Detroit
Edison

EF2 - 53,455

Reference: Enrico Fermi Atomic Power Plant Unit 2
NRC Docket 50-341

Subject: Responses to Questions from Gerry Mauch

FIGURE H.II.K.3.18-2

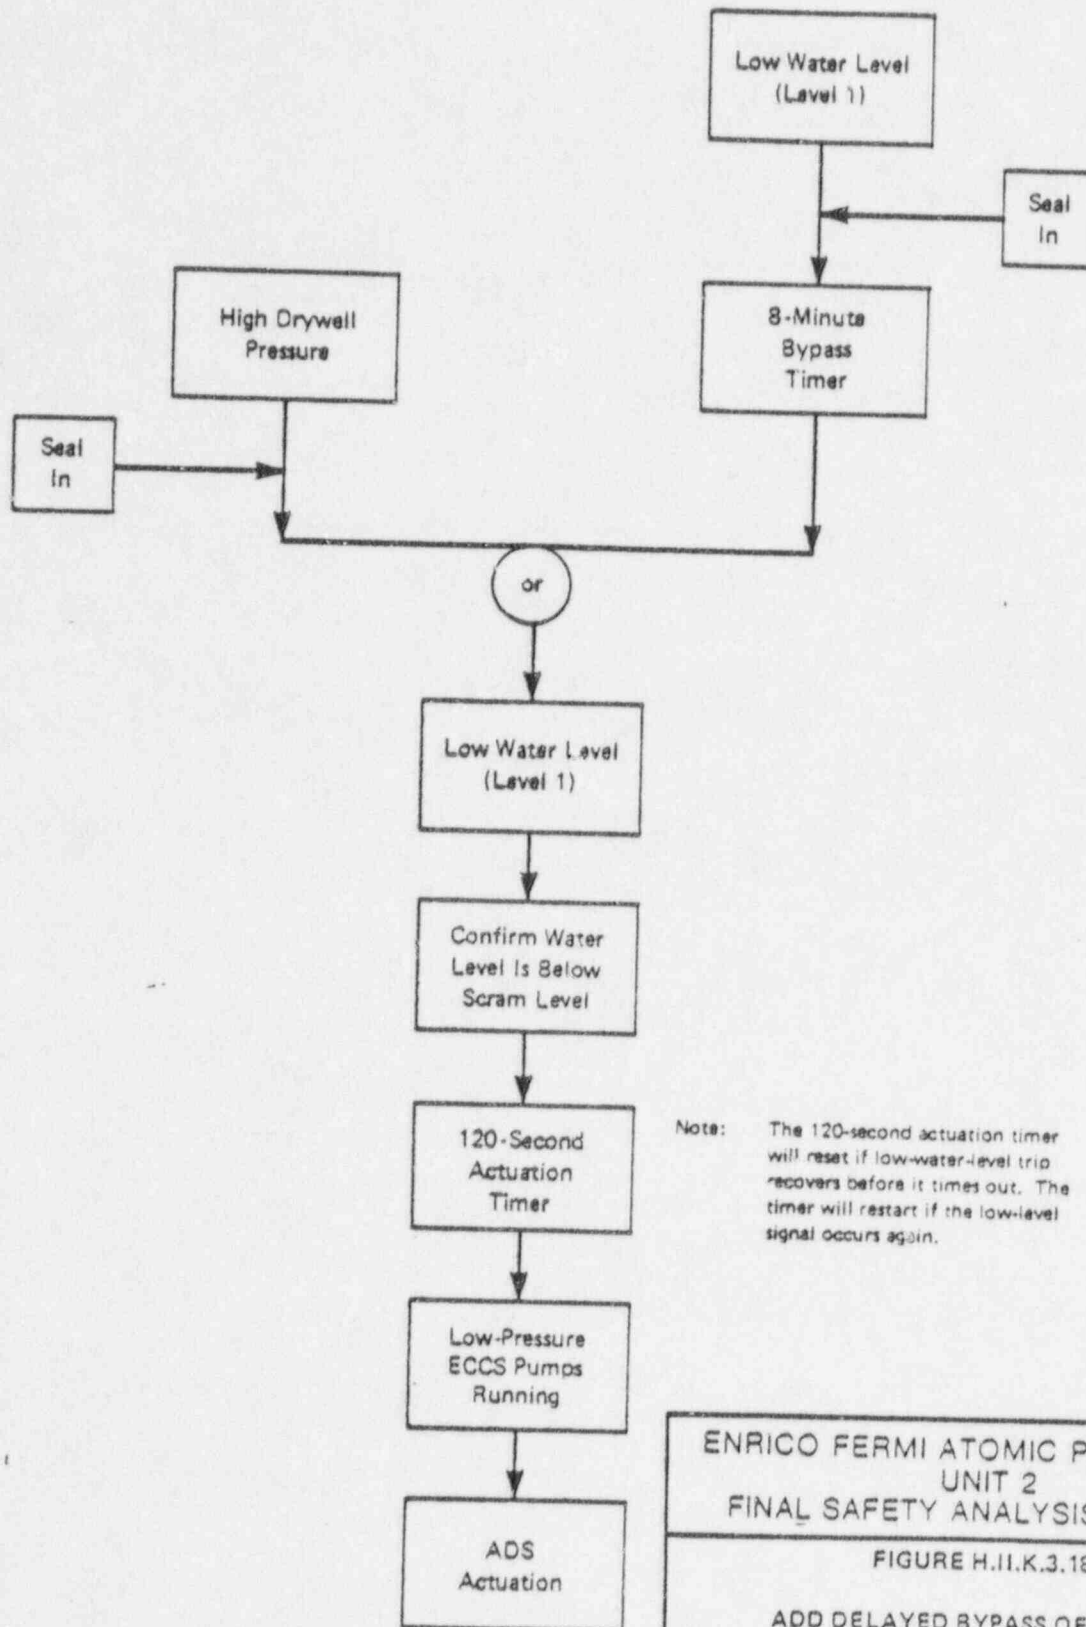
At the I&C exit interview, the staff reviewer requested that the specific design modification to the ADS initiation logic be identified, the attachment indicates clearly the method being employed to mitigate this concern.

Of the two alternatives recommended by the BWR Owners' Group study, the addition of a bypass to the high drywell pressure trip if the reactor water level remains below the low-pressure ECCS initiation setpoint for a sustained period, is judged to be the preferred solution.

This will be accomplished by installing a "bypass" timer activated on low water level (Level 1). When this timer runs out, the high drywell pressure trip is bypassed and the ADS is initiated on

35 Figures H.II.K.3.18-1 and H.II.K.3.18-2 show the logic for this alternative, with the bypass timer started on Level 1. A time delay of 8 minutes has been chosen for the Fermi 2 plant from the analyses presented in NEDO-24708 (Figure Group 3.5.2.1-33). The results of these analyses demonstrate that adequate core cooling is ensured for isolation events, even with the ADS blowdown delayed 10 minutes after Level 1. Figure Group 3-1 shows the same analysis assuming a stuck-open relief valve.
